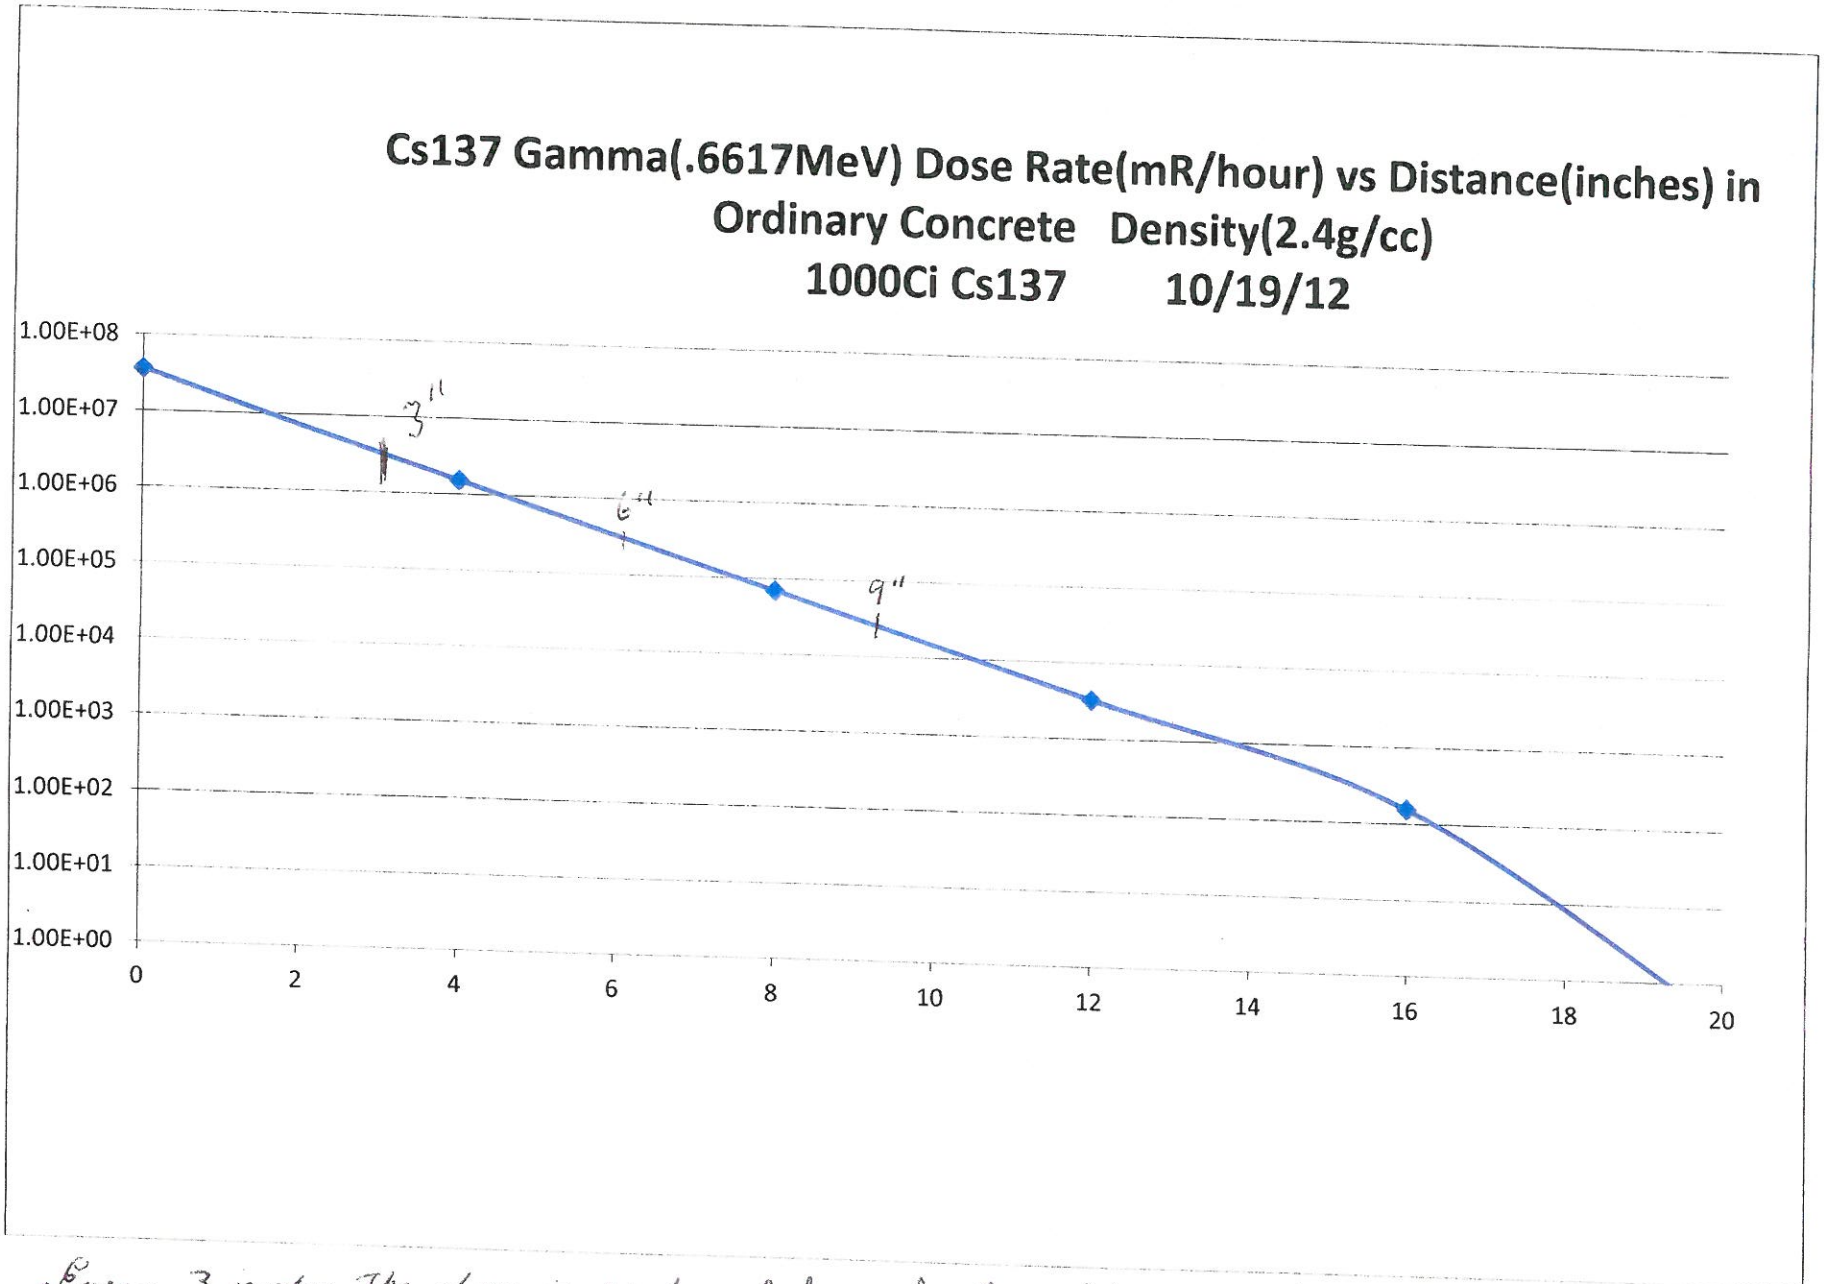
- Every 3 inches the dose is reduced by a factor of 10 in ordinary concrete
- What is the density of WESF concrete?

Their calculated maximum dose at the wall (concrete) was "conservatively" estimated at 3.3 x 10^11 rad (Projected to 4 x 10^11 rad if they hadn't rearranged the capsules).

- Verify these data
- Calculate dose from initial load, duration, configuration using MCNPX Codes
- Is the water contaminated?

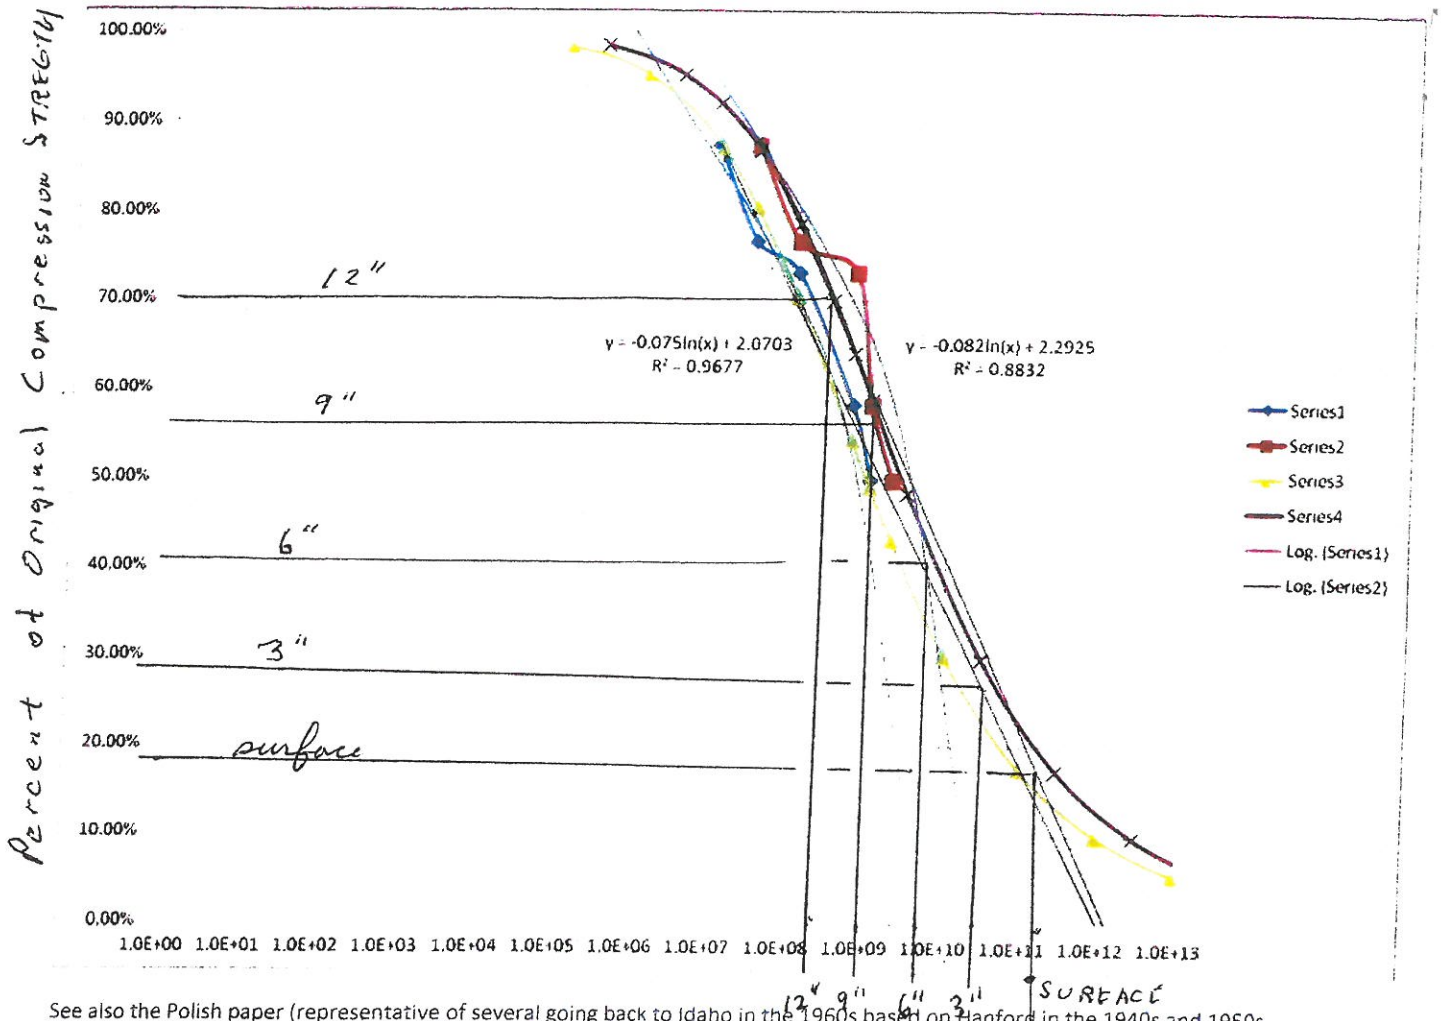
See also the Polish paper (representative of several going back to Idaho in the 1960s based on Hanford in the 1940s and 1950s.

- How thick is the WESF concrete?
- Which accidents in the safety basis scenarios rely on strength? What is the probability of them occurring?
